Staff Report

Knoxville Historic Zoning Commission

File Number: 9-E-24-HZ

Meeting:	9/19/2024
Applicant:	Sean Martin, Open Door Architecture
Owner:	Bess Connally

rear elevation

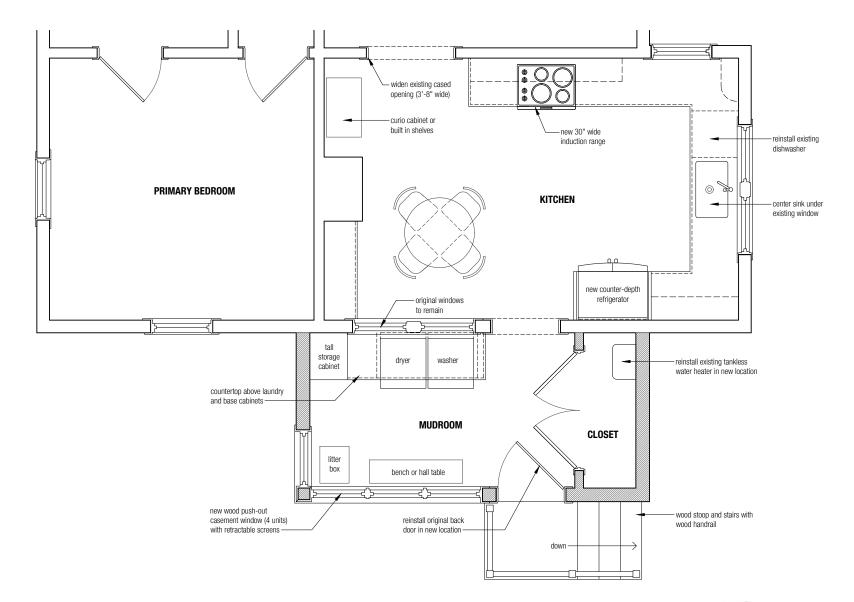
2. All work is concentrated on the rear elevation, a non-charater-defining elevation which is not visible from the right of way. The existing 64 sf. rear addition to be removed is the original porch that was enclosed sometime after 1950, and featuring a non-original double-hung aluminum clad wood window, a non-original door, and the original back door. Removal of the addition is appropriate due to its deteriorated condition and the retention of the original back door. The 110 sf. proposed addition expands the floor plan of the existing addition and features a wooden stoop, resulting in minimal modifications to the existing profile of the house and providing symmetry. Placement of the addition is appropriate.

3. The proposed addition is compatible with the primary house. The proposed addition will feature a gable roof that matches the existing pitch and eave overhangs of the house, wooden support brackets and flashing, smooth finished Hardie Lap or poplar wood lap painted siding, corner board, and the original back door. These features maintain the architectural details and materials of the original house and meet design guidelines. Smooth-finished fiber cement siding has been approved for new additions in Fourth and Gill.

4. The proposed addition is differentiated from the original house by its parge-coated cinderblock foundation, wooden stoop and railing, and four wooden casement windows. These windows differ from the wooden double-hung windows that characterize the house, but they are appropriate for a bungalow from the period and provide higher transparency that suggests an addition. Wood windows meet the design guidelines.

Staff recommends approval of 9-E-24-HZ as submitted.
